Change Order

PROJECT (Name and address):
Radcliff Elementary School Renovation
- Phase 3
1145 S. Dixie Boulevard
Radcliff, Kentucky 40160

CHANGE ORDER NUMBER: 011
DATE: September 15, 2011

PROPOSAL REQUEST NUMBER: 010

Drawing C/ALT2.1 - Partial Ref. Clg. Plan
Drawing D/ALT2.1 - Partial Lobby 100 Building Section
Drawing S/A4.3 - Partial Soffit Section Detail

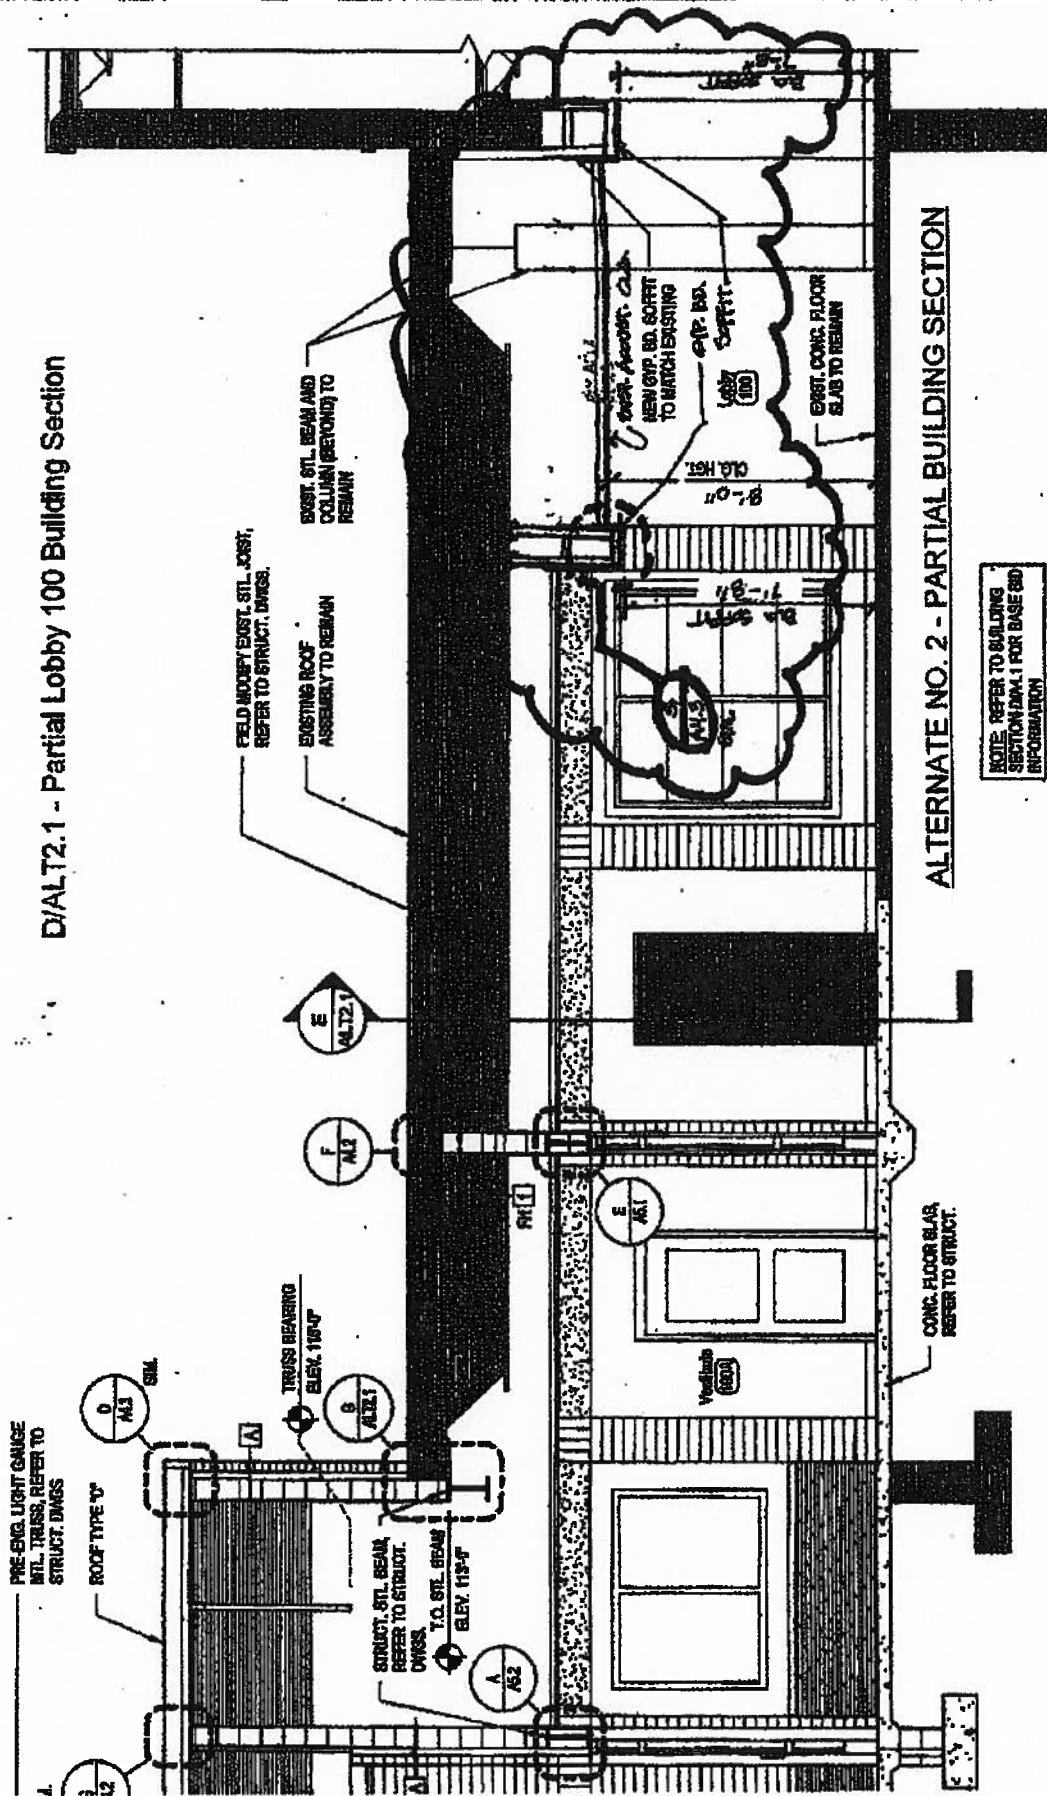
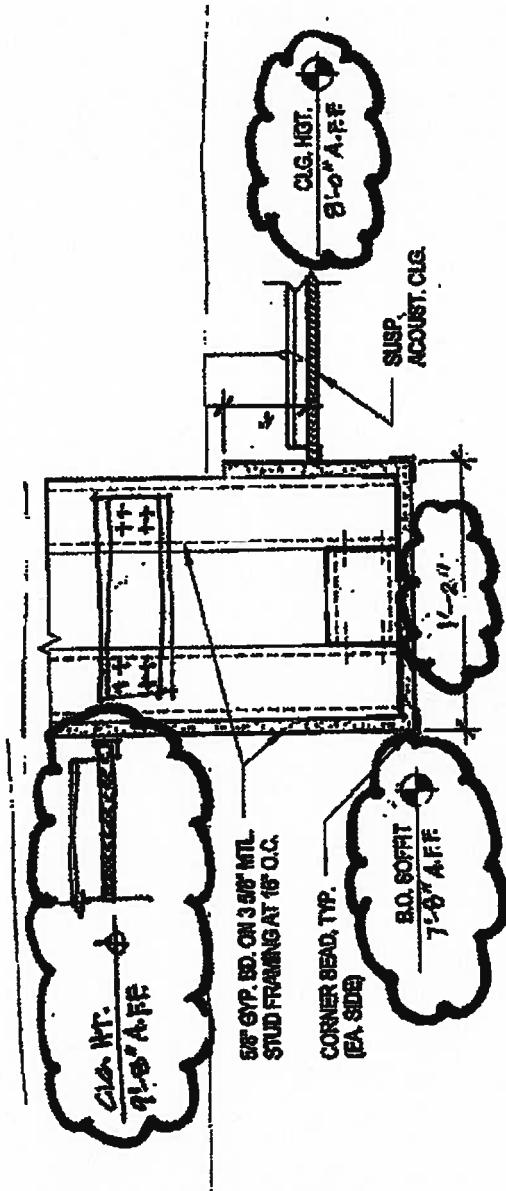
Provide material and labor cost to install an additional 1'-2" wide gypsum board soffit within Lobby 100. Upon demolition and removal of existing suspended ceiling/soffits, the existing masonry walls surrounding Lobby 100 into Existing Lobby 125 are approximately 8'-4" a.f.f. The construction drawings require a new suspended acoustical ceiling be installed in this area at 9'-8" a.f.f. Existing perimeter masonry walls and existing mechanical/plumbing items in this area will not allow the new ceiling to be installed at this height. In order to maintain 9'-8" a.f.f. for suspended ceiling in the new Lobby 100 area, a gypsum board soffit must be installed at 7'-8" a.f.f. in order to provide a transition from the higher ceiling to the lower ceiling, accommodating the existing masonry wall height and mechanical/plumbing items. The suspended ceiling in this area is to be installed at 8'-0" a.f.f.
